**ADDENDUM NO. 3
TO
CONTRACT DOCUMENTS &
SPECIFICATIONS**

ISSUED 10/22/2025

**Hays County
City of Dripping Springs**

West Interceptor Segment 2

CREEK CROSSING PLAN

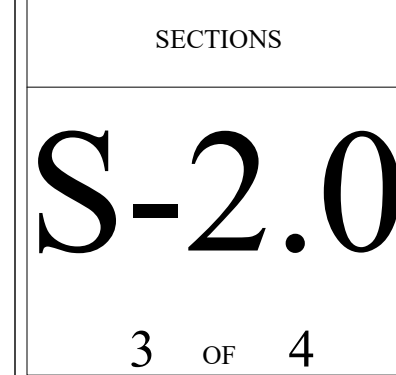
- Updated structural design sheets are provided to better clarify the fill materials used for the structure.
- The city has determined the contractor will have to haul treated effluent from the city's wastewater treatment plant located (23127 W 150, Driftwood, TX 78619). Vehicles shall enter using the dirt road and drive at a maximum of 10 mph while on the property.

- Structural needs to identify if select fill will be utilized on the bank of the reinforced concrete crossing.
 - Answer: *Select fill will be utilized on the downstream side of the retaining wall.*

- Answer: *The 12' call out of the structural cross section does not indicate the amount of the crossing crest to be removed but the distance from retaining wall to crest tie. See structural sheets.*
